YUCCA MOUNTAIN SITE CHARACTERIZATION PROJECT

YMP/TR-003-NP-Rev. 1

TOPICAL REPORT

**PRECLOSURE
SEISMIC DESIGN METHODOLOGY
FOR A GEOLOGIC REPOSITORY
AT YUCCA MOUNTAIN**

Figure 1-1. Steps in Seismic Hazard Assessment and Development of a Seismic Design Basis

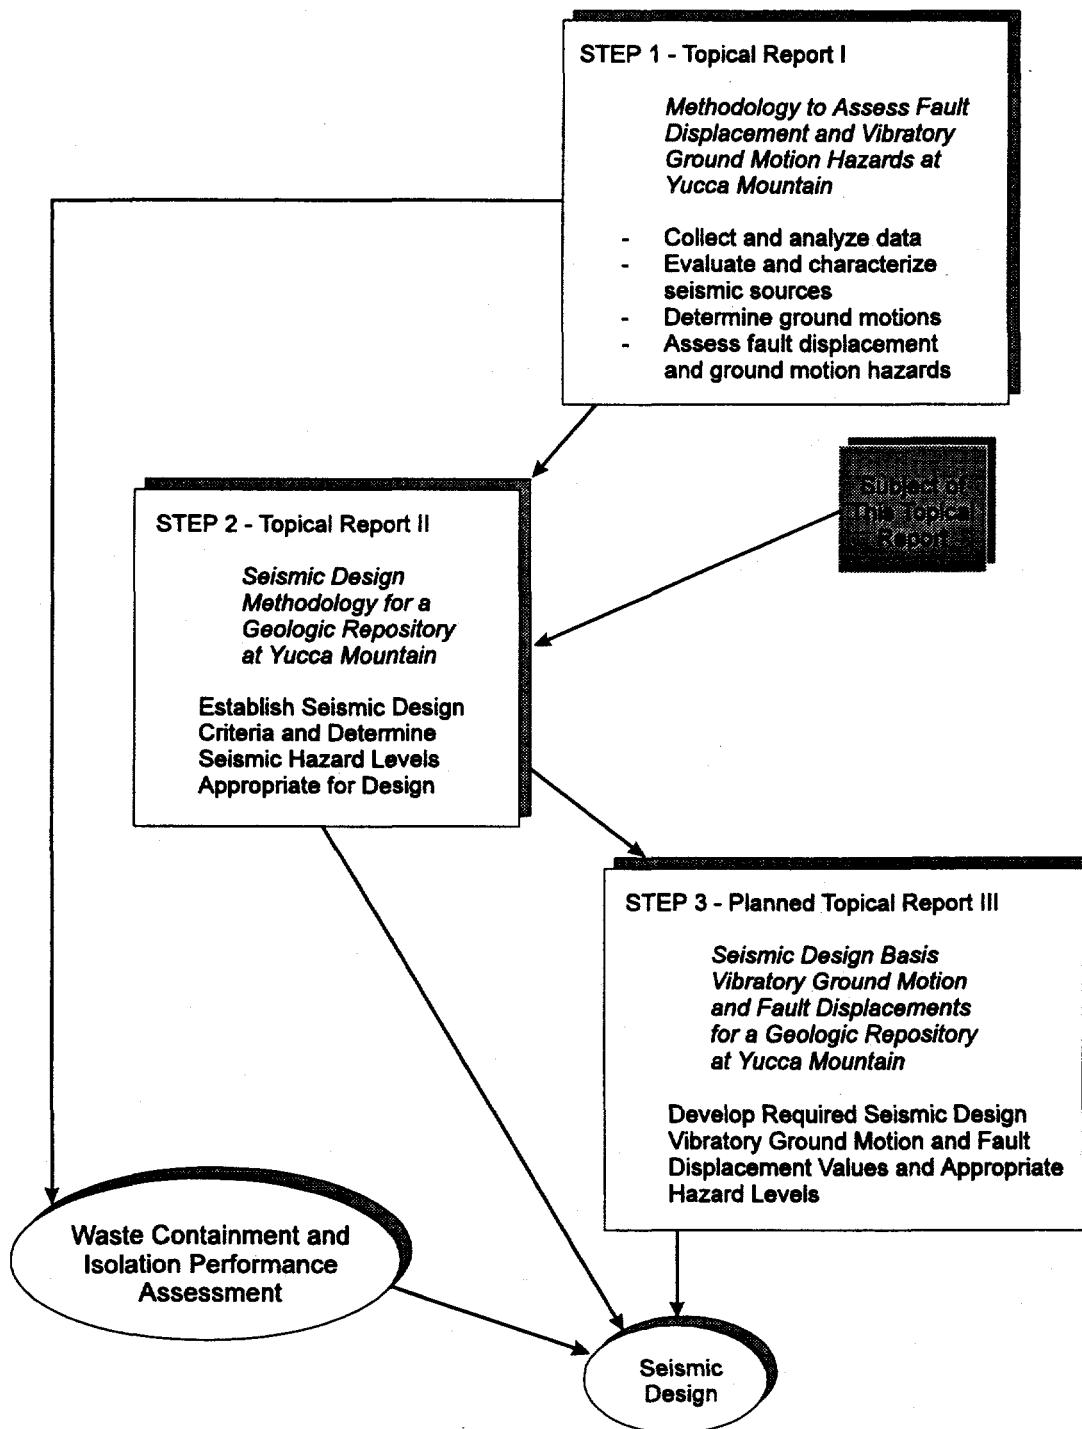
COMMENT 1

Following Nataraja (1995), Figure 1-1 has been corrected to show explicitly that both preclosure and postclosure performance objectives must and will be considered in the final design of structures, system, or components (SSCs). Also following Nataraja (1995), Figure A-1 has been added to illustrate the DOE's process for integrating design, performance assessment, requirements definition, and site characterization. A discussion of DOE's process for integrating all preclosure and postclosure design requirements has been added to Section 1.3 and is detailed in Appendix A of the revised report. Appendix A also examines the linkage between the preclosure seismic design of emplacement drifts, the potential for repetitive seismic loading, and the postclosure performance requirements for the emplacement drifts.
